BEFORE THE DESIGN REVIEW COMMITTEE
OF THE CITY OF ASTORIA

ORDER NO. DR17-~~03~~⁰³

STAFF REPORT AND FINDINGS OF FACT

SUBJECT: DESIGN REVIEW REQUEST (DR17-03) BY ASTOR VENTURE LLC (GARRY DON VALLASTER) TO CONSTRUCT AN 11,580 SQUARE FOOT ONE-STORY COMMERCIAL BUILDING (ASTORIA CO-OP GROCERY) AT 2350 MARINE DRIVE

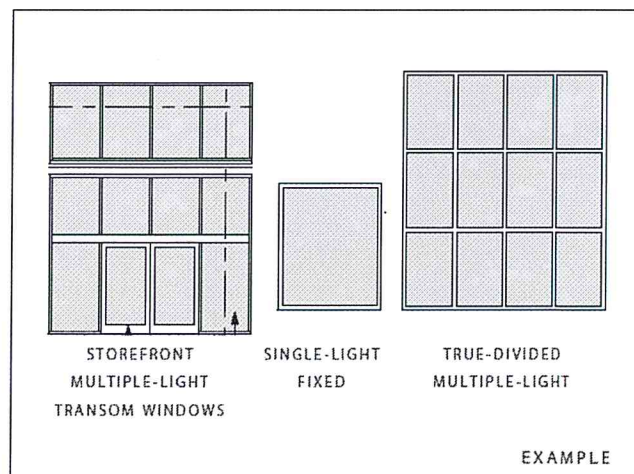
Finding: Proposed windows include both aluminum and fiberglass materials. Large window area is allowable for commercial sites.

However, spandrel and frost glass is discouraged. The revised design indicated added windows on the west side of the building which are clear and allow pedestrians to look into the store. Additionally, an espalier trellis for fruit trees and a series of along the west.

The new design indicates larger fiberglass, clear windows and the addition of shrouds around the smaller windows.

2. Glass in all proposed windows are clear and not frosted or spandrel. Additional window and window treatment as shown on the revised plan shall be installed. Any windows with grids shall be true divided or shall have external grids.

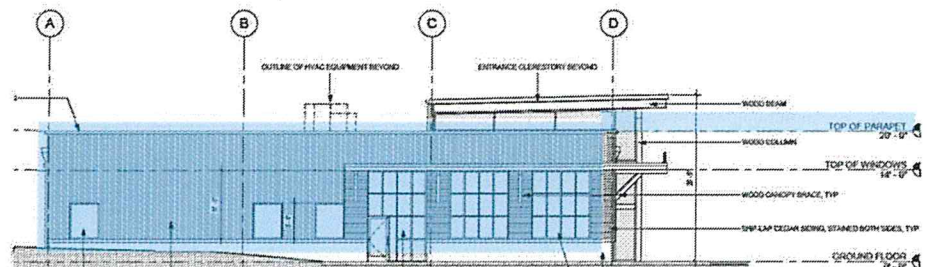
Finding: The structure will have a flat roof which incorporates a parapet wall, and large wood beam canopy. Flat roofs behind a parapet are encouraged design on commercial buildings. Other encouraged commercial roof designs include single gables with low pitch, repetitive gables with steep pitch or design which incorporate skylights. Adjacent commercial structures have a variety of roof designs and levels such as the CMH Cancer clinic. The awnings add an element to break up the roof design while maintaining encouraged design elements for commercial structures. The signage near the roofline shall require a sign permit, and should it extend about the roofline, it shall conform to dimension requirements in Article 8 for signage.

SE PERSPECTIVE

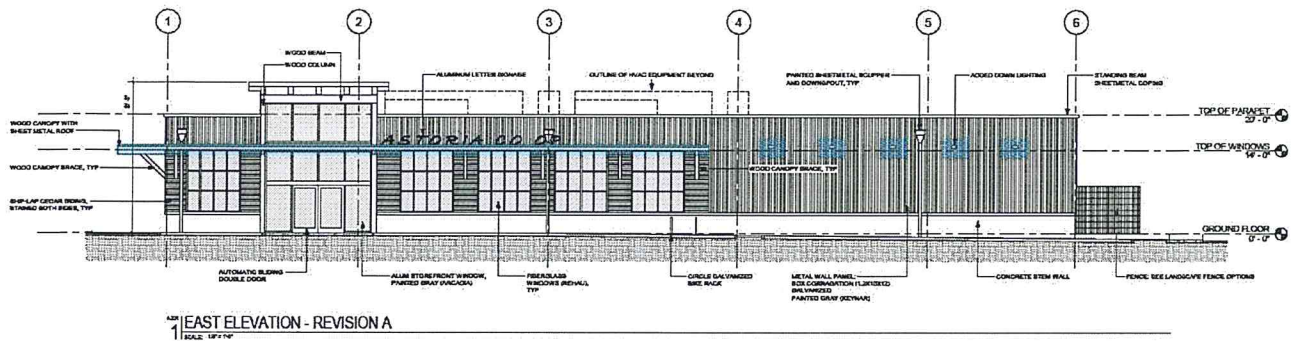
Finding: The applicant proposes aluminum letter signage on the east elevation near the main entrance. The applicant noted the co-op was exploring possibilities for a new logo and lettering. With that process is underway, the actual proposed signage is expected to change. The lettering below is a likely area where signage will be installed.

Signage and any advertising at the site will need a sign permit and will be reviewed against the signage requirements in Article 8 and Article 14 of the Development Code. Without additional details on the proposed dimensions and

design for the signage, this guideline is not met. DRC directed Community Development staff to review signage when it is submitted with a sign permit. If needed it may be reviewed by the DRC as an amendment to an existing permit. Signage shall not be installed prior to review by staff and/or the DRC.

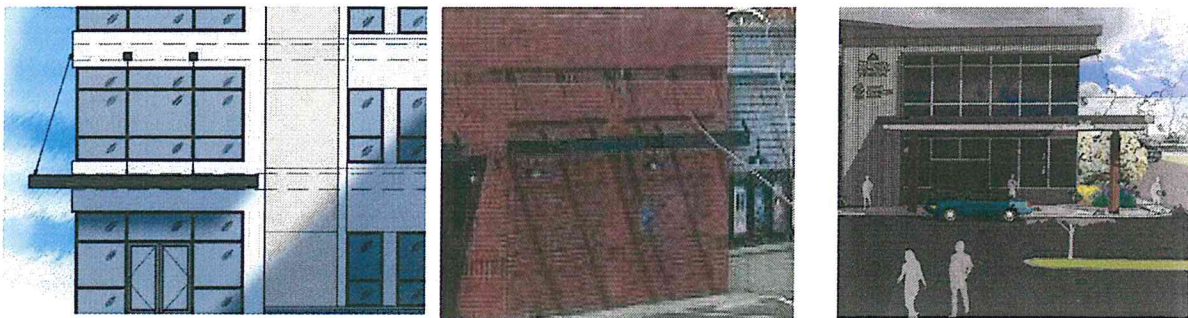
The fixed wooden canopy for rain protection and ease of customer entry is encouraged in commercial buildings. The use of wood is encouraged, especially in this location which is near the historic wooden mill that once operated near the site. Examples of other successful awning designs are below. The wooden canopy meets the design criteria. Additionally, a trellis has been extended along the south façade to support a wisteria vine and add definition to the building. This criteria is met.
